# CITY OF ALBUQUERQUE

RE: **Zocalo Lofts**  
**507 4<sup>th</sup> St SW**  
**Grading Plan and Drainage Report**  
**Engineer's Stamp Date: 2/14/18**  
**Hydrology File: K14D112**

Zocalo Lofts Comment Responses

RE: **Zocalo Lofts**  
**507 4<sup>th</sup> St SW**  
**Grading Plan and Drainage Report**  
**Engineer's Stamp Date: 1/18/18**  
**Hydrology File: K14D112**

C201

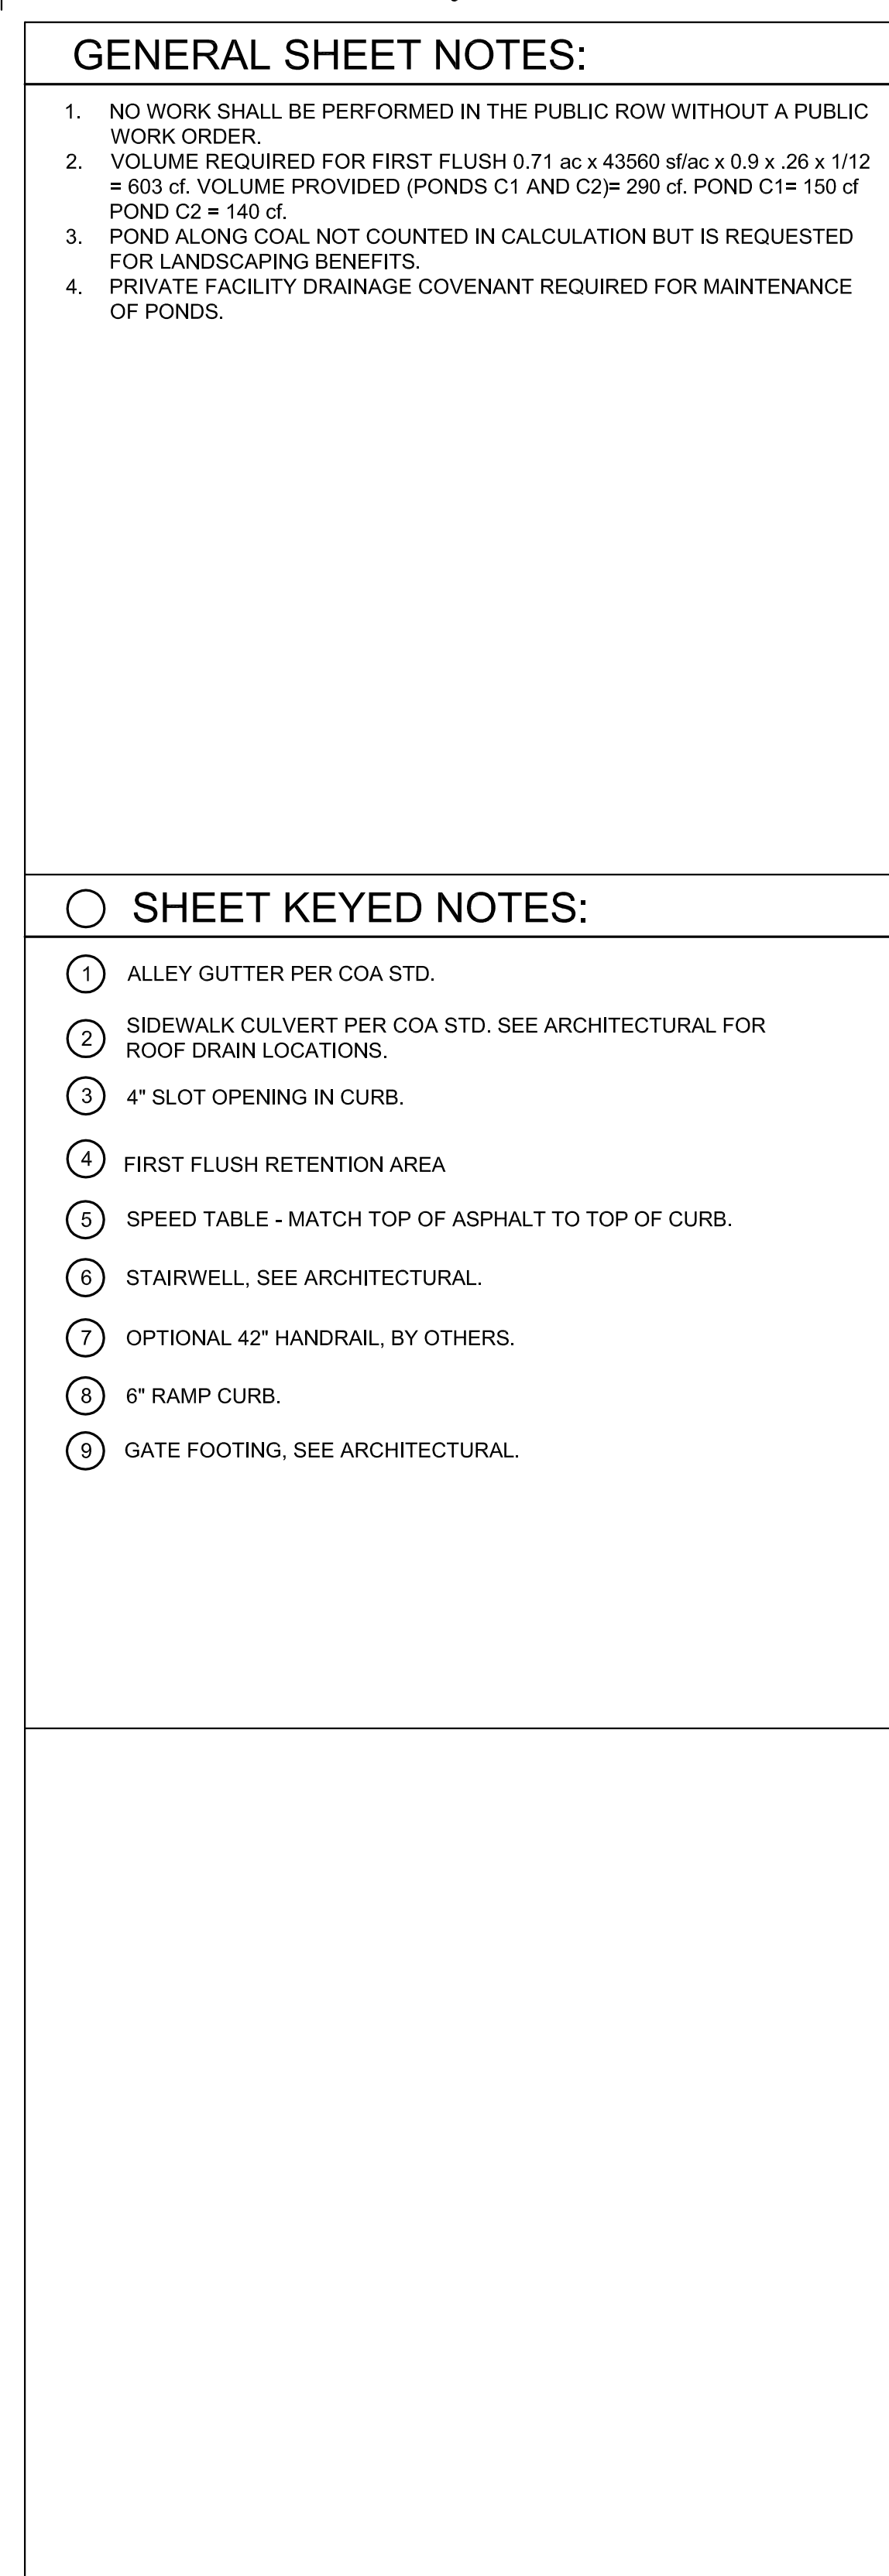
1. This site qualifies as redevelopment and is only required to retain runoff from the 80<sup>th</sup> percentile storm (Vol. =  $0.26 \times \text{Imp. Area}$ ). Consider only the private property.

2. Quantify the first flush volume that will flow to each ponding area (Basin B). Demonstrate that each ponding area is sized for the area draining to it.

3. First flush ponding in the public ROW cannot be used to satisfy the first flush requirement or to reduce the runoff from the site (Basin A). If this runoff cannot be ponded onsite, payment of Fee-in-Lieu will be required.

4. Payment of Fee-in-Lieu is required for areas that free discharge to the Public ROW. Quantify this volume and state on plans. Alternately, provide appropriately sized first flush ponding.

5. Existing spot elevations are illegible; please correct.
6. Include existing grades on the adjoining lot to the west. Are there any walls proposed and will they be contained on the subject property?

7. Add note on the plan that "No work shall be performed in the public ROW without an approved Work Order."

1. Retention Volume =  $0.26 \times 0.71 \times 0.9 \times 43560 / 12 = 603$  c.f. total. Pond C1 and C2 contain 150 c.f. and 140 c.f. respectively.
2. I think this is Basin C but calculations are provided
3. Roof drains are pointed toward Coal. Depressed landscaping is for water conservation only and is not counted in the first flush requirement
4. Ponding required and provided are noted with a payment in lieu expected.
5. Noted, and corrected
6. Contour to the west is labelled. No runoff from property to the west is currently entering site and all work will be confined to subject property
7. Note added
8. Note added
9. Noted
10. Noted
